**Historic Architectural Review Commission
Staff Report for Item 10b**

Meeting Date: July 28, 2015

Application Number: H15-01-1012

Address: #1000 Southard Street

2 EXIST. WEST ELEVATION (RIGHT)
A-3 Scale: 1/8" = 1'-0"

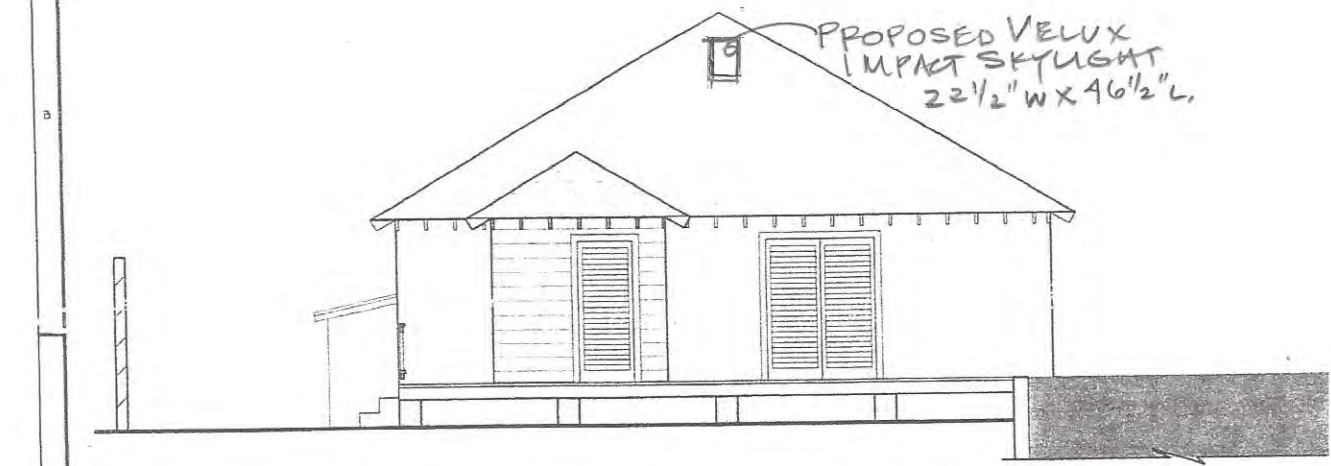
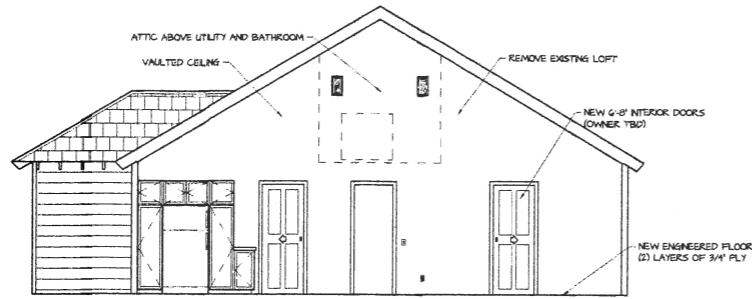
For the proposed doors for the east and south elevations, including the bathroom addition, staff opines that the elevations have been altered through time; therefore, the proposed doors may be considered an appropriate design.

The proposed skylight will be on the back portion of the hip roof and will be slightly visible from Grinnell Street. Staff recommends that the skylight be flush-mounted to the roof and to be flat.
